**Wallingford Zoning Board of Appeals Meeting
Monday, March 15, 2021
7:00 p.m.**

RE: Staff comments for the March 15, 2021 ZBA Meeting

- #21-001/VARIANCE REQUESTS/Andrade/26 Beechwood Drive**
Applicant requests a side yard setback of 8 ft. where 8 ft. and 19.8 ft. exist and 20 ft. is required and a front yard of 28.5 ft. where 33.5 ft. exists and 40 ft. is required to construct an addition, full vertical addition and 5 ft. x 10 ft. covered front porch/entryway. The new two-story addition proposed for the southeast side of the dwelling is compliant with regard to Southeast side setback. Addition to southeast will eliminate existing non-conformity with regard to that setback. Dwelling is currently non-conforming with regard to northwest side setback (8 ft.) and front setback (33.5 ft.). Variances are required to expand the existing dwelling vertically. Proposal to add a 5 x 10 ft. single story front porch/entryway expands the existing non-conformity by 5 ft., reducing front yard from 33.5 ft. to 28.5 ft. Despite the undersized lot, proposal is compliant with respect to building coverage requirement of 15% maximum.

TO: AMY TORRE, ZONING ENFORCEMENT OFFICER
VIA: FAX 2095
FROM: ERIK

26 Beechwood Drive

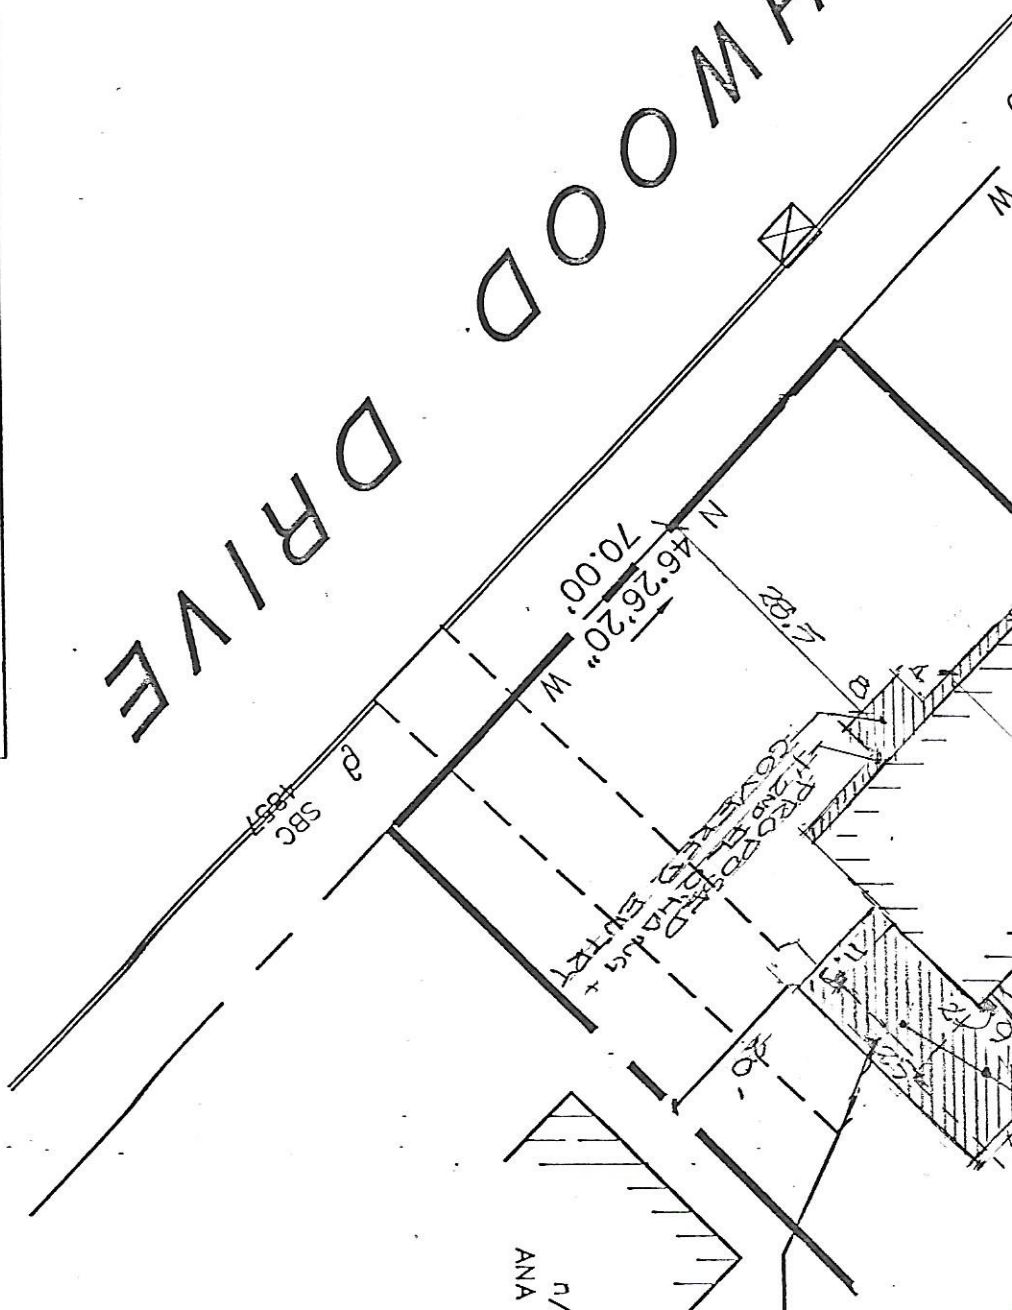
It appears that the subject application includes an addition to the existing structure. The owner should take into consideration the location of the existing water service and sanitary sewer lateral to the building when planning a building addition to ensure that the water and sewer lines are not in conflict with the proposed addition.

If the existing utility lines are in conflict with the proposed building addition it may be necessary to relocate or modify the utility lines to avoid conflict.

- The Wallingford Water and Sewer Divisions will assist the owner in determining the location of the existing water service and sanitary sewer lateral for the building. If it is found that the utility lines will be in conflict with the proposed building addition the owner may be required to relocate or modify said utility lines if determined necessary by the Wallingford Water and Sewer Divisions.
- If it is required to modify, repair or replace any underground sanitary sewer or water line as part of the work proposed for the addition, it will be the Owner's responsibility to pay all fees and charges associated with such work and engage a properly licensed, insured, and bonded plumbing contractor to obtain a permit from this office to perform all such work in accordance with the Wallingford Water and Sewer Technical Standards and Details.
